City of Portland, Maine - Building or Use Permit Application
 389 Congress Street, 04101 Tel: (207) 874-8703, Fax: (207) 874-8716

Permit No: 04-1519	Issue Date:	CBL: 406 F053001
-----------------------	-------------	---------------------

Please find below the response to your comments on the application for a building permit for Lot 3, Stepping Stone Lane (406-F-53):

From: Tammy Munson
To: port-web:frank@[windemerehomes.com]
Date: Thu, Nov 4, 2004 9:32 AM
Subject: Re: Comment resolutions on 406-F-53

SITE PLAN

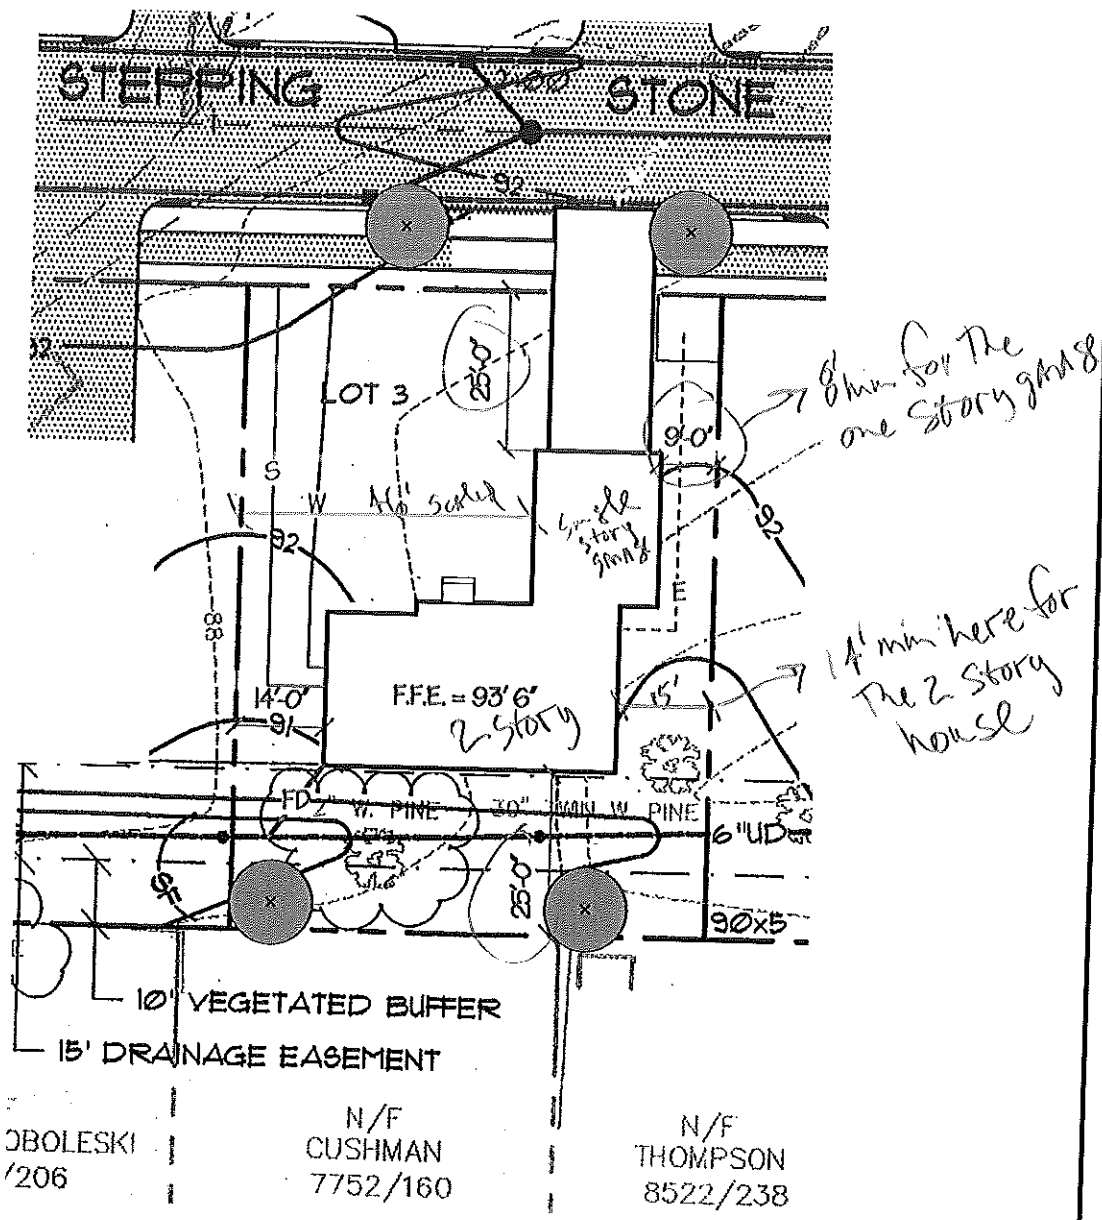
NO FEAT Deck
Shown

Side Yard -
Garage only 1 Story → 8' min - 9' @ 46' scaled
House - 2 Story → 14' min - 14' @ 15' shown
Projections - front steps 4' x 5'

Height - 35' min - 27' scaled to ridge

NO Daylight Basement Shown

M **Indefinite Homes**
 PROJECT: **COVENTRY**
 DRAWING: **FRAMING AND FOUNDATION PLANS**
 SCALE: **1/8" = 1'-0"**
 SHEET: **A-4**

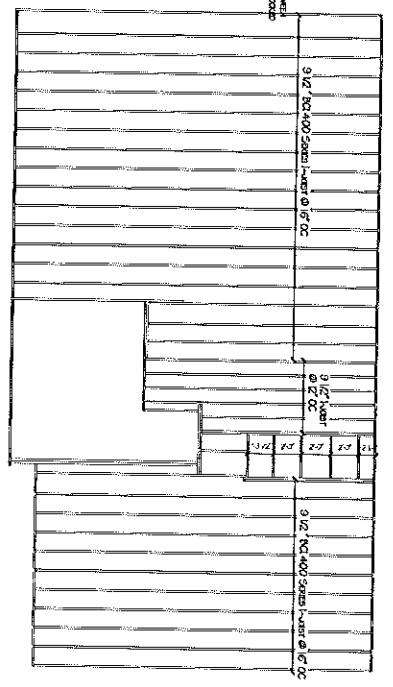
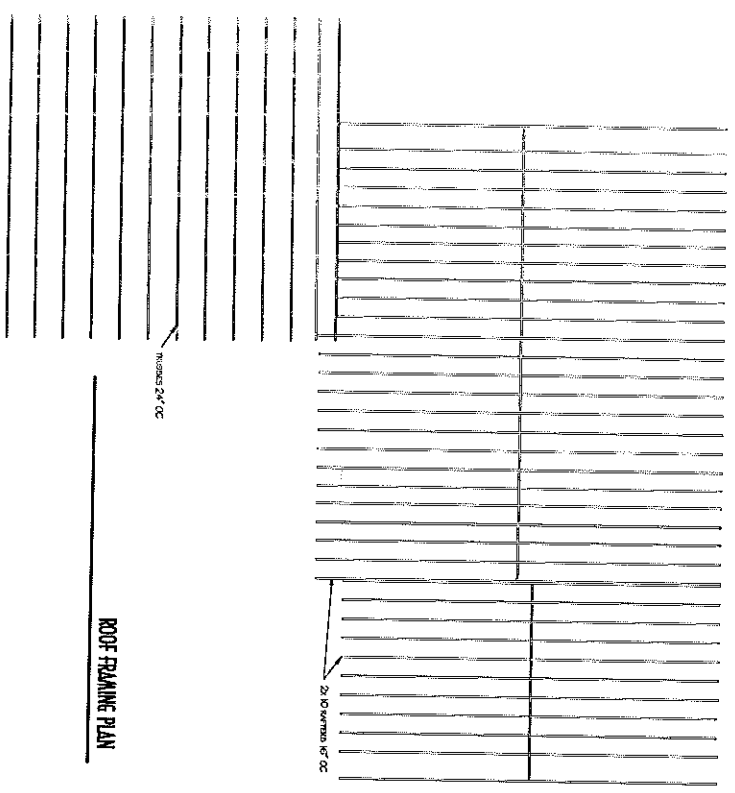
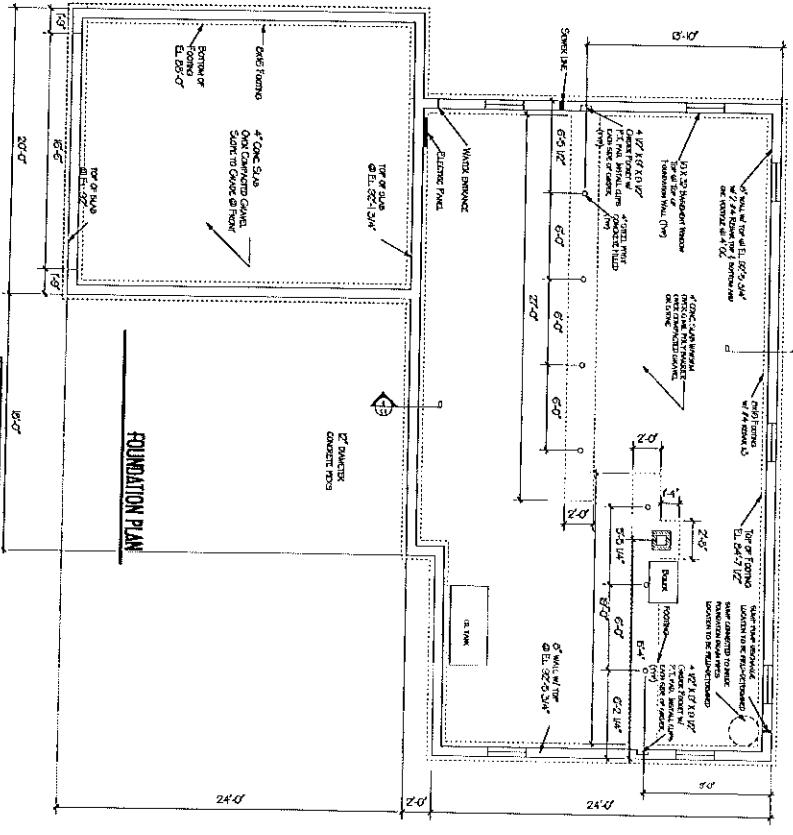
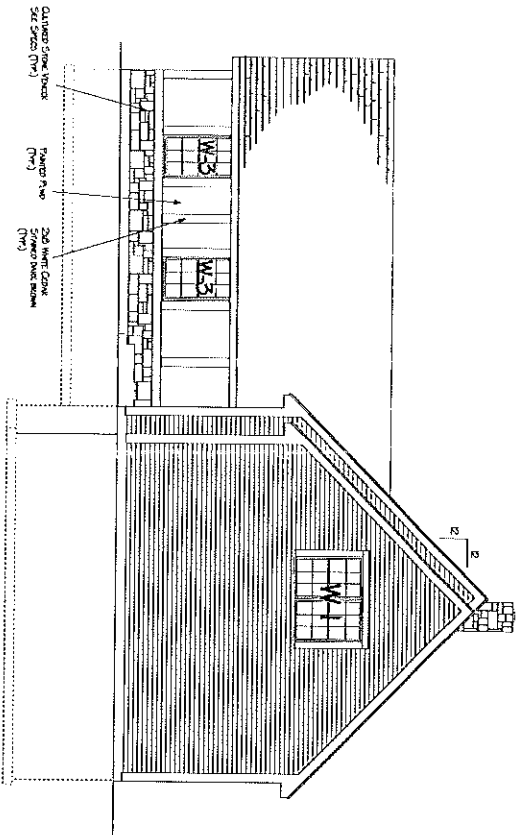
- ✓ 1. Draft stop material not shown around chimney.
This is in text form on the Framing Plan, Sheet A-4
- ✓ 2. The header for the 6 ft. window should be 2-2x12's or 3-2x10's.
This header has been changed to 3-2x10's
- ✓ 3. Garage door header not called out.
This has now been specified as 2-2x12's.
- 2nd flr
Stair opening ✓ 4. Lally columns near stair opening needs to be moved or added.
Girder size allows 8 ft spacing of columns, so I re-spaced the columns placing one at the end of the girder.
5. No ASTM listing for roof material.
Code allows either ASTM or UL. UL listing for Crowe Authentic shingles was provided on CD. However we may be using an alternate material, TAMKO Lamarite, and the UL cert for Lamarite is attached.
